**Subject: USEPA CCR Rule and IEPA Part 845 Rule Applicability Cross-Reference
2021 USEPA CCR Rule Periodic Certification Report
GMF Pond, Duck Creek Power Plant, Canton, Illinois**

**2021 USEPA CCR RULE PERIODIC
CERTIFICATION REPORT
§257.73(a)(2), (c), (d), (e) and §257.82
GMF POND
Duck Creek Power Plant
Fulton County, Illinois**

**Dynergy CCR Program - Duck Creek Power Plant
GMF Pond Section B-B
Canton, Illinois**

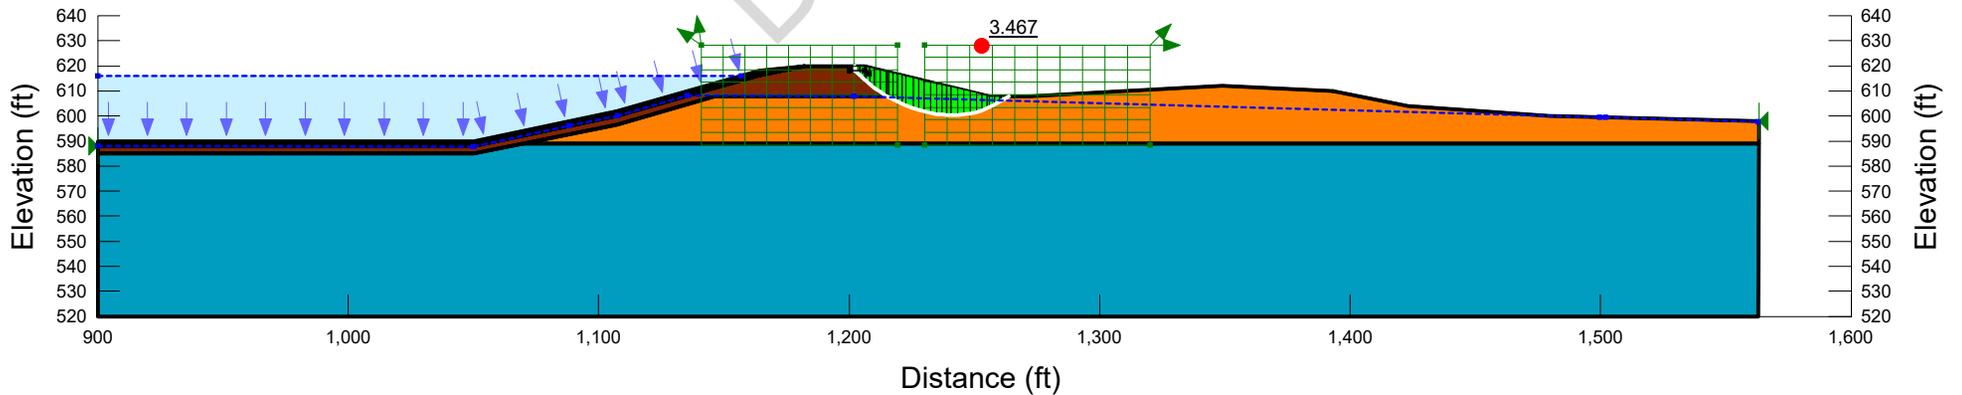
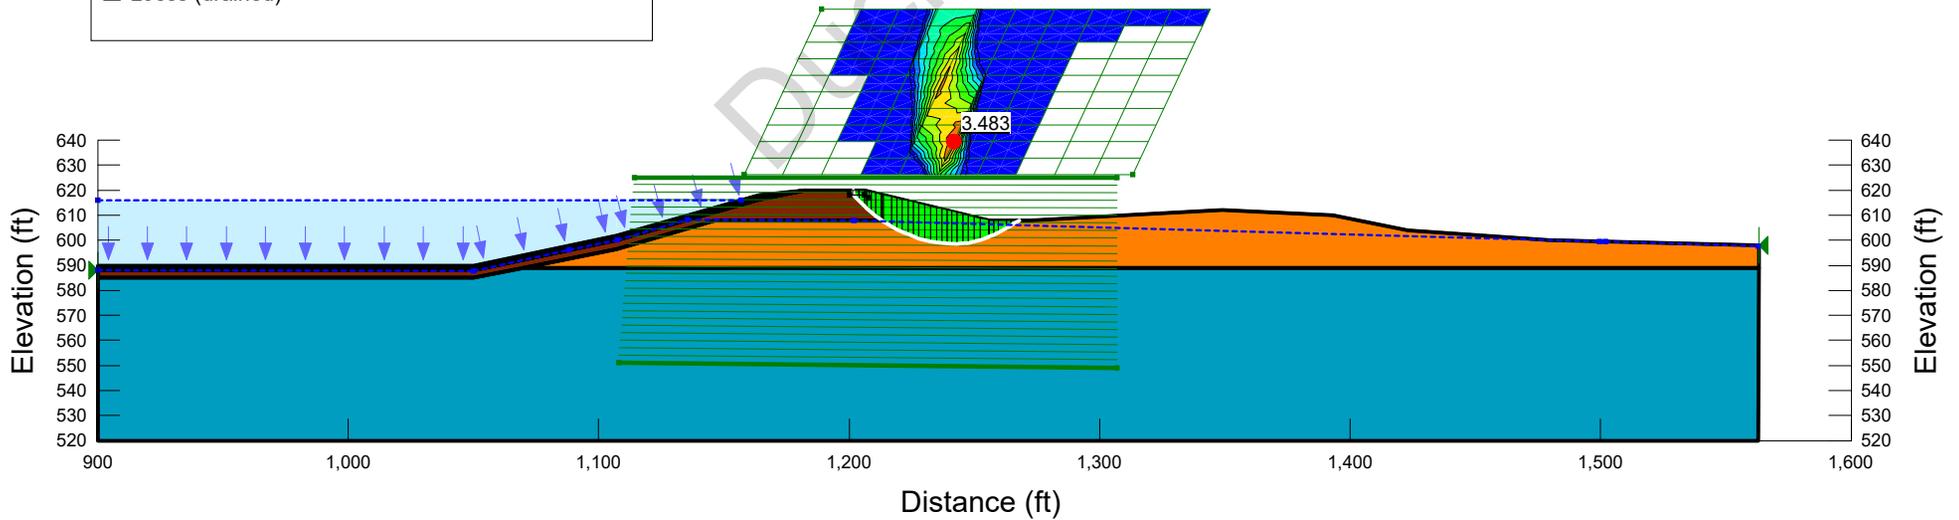
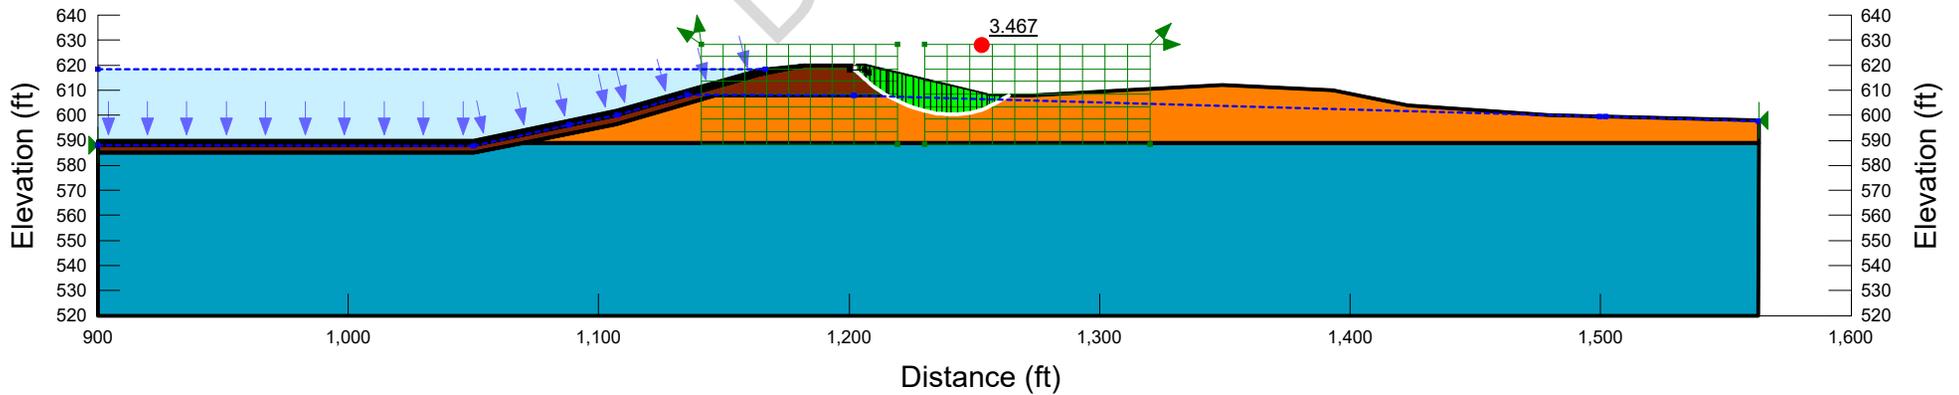
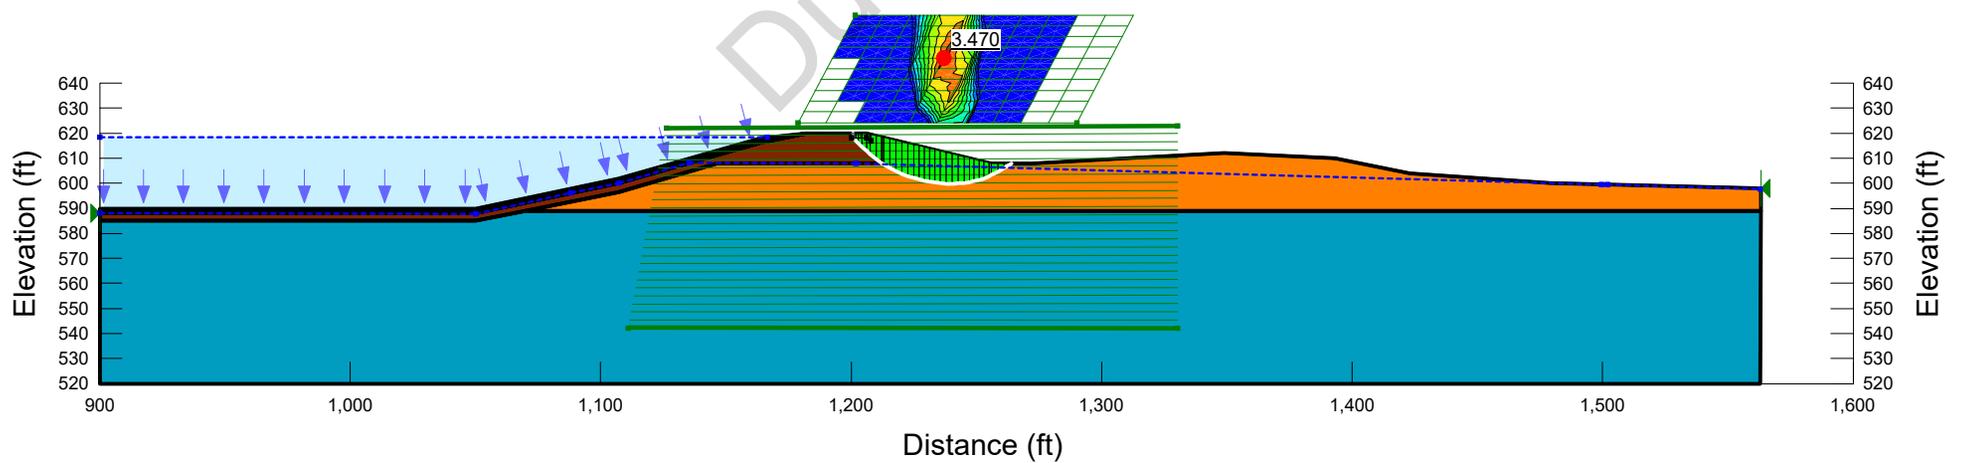
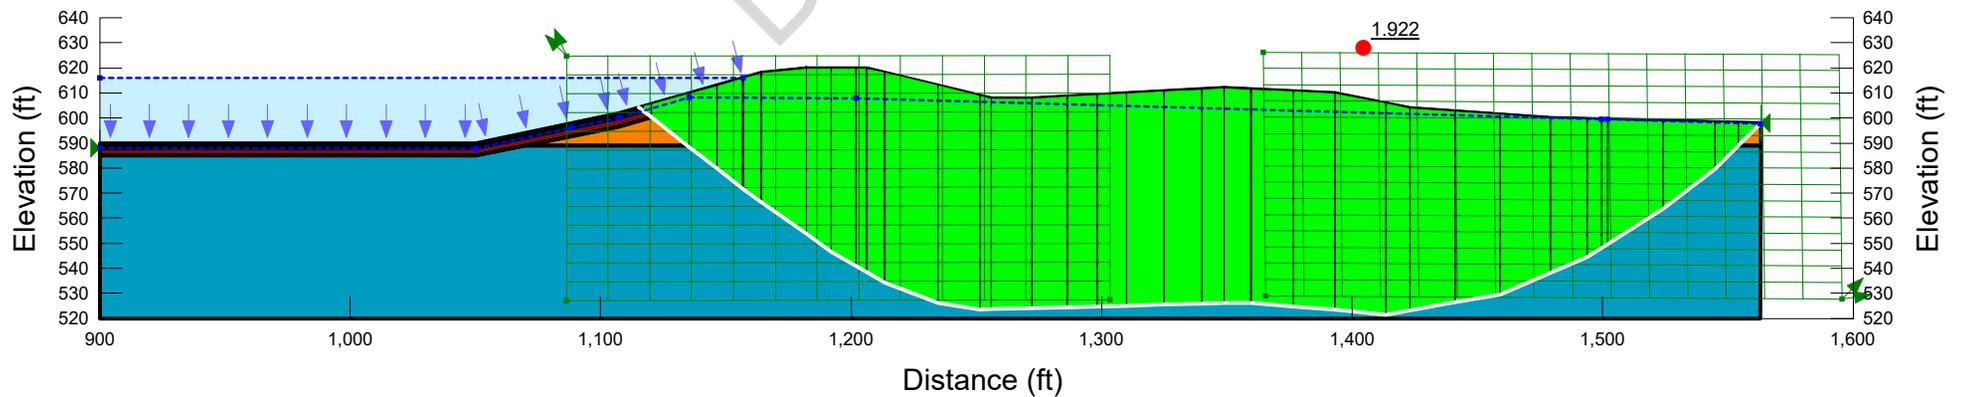
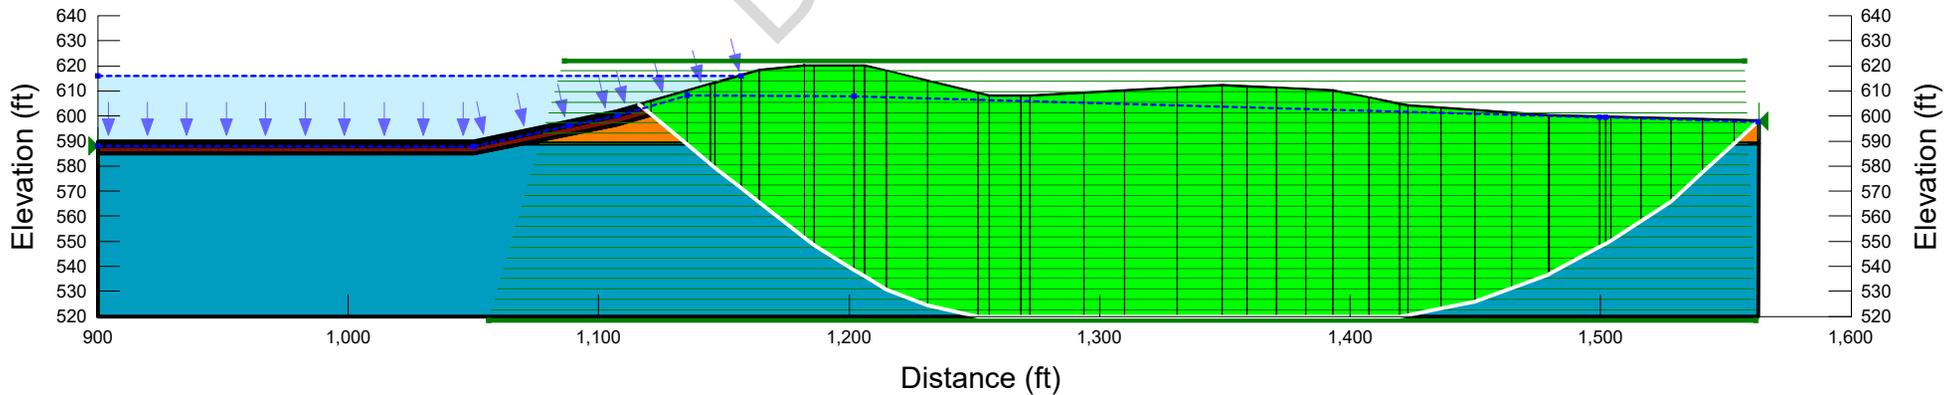
- The Initial SFA utilized a single cross-section (A-A') along the eastern embankment where the exterior slope is approximately 8 ft tall. However, the maximum height of the exterior slope is approximately 11 ft at the southwest corner of the embankment.

Following review of the Initial SFA ([5], [8]), Geosyntec developed a new slope stability analysis cross-section (B-B') at the southwest corner of the GMF Pond embankment to account for the maximum embankment height of 11 ft. The model was developed utilizing the following approach and input data:

Factors of safety from the Periodic SFA (cross-section B-B') and Initial SFA (cross-section A-A') are summarized in **Table 3** and confirm that the GMF Pond meets the requirements of §257.73(e)(1). A location of the cross-section B-B' in plan and analysis output data for cross-section B-B' is provided in **Attachment D**.
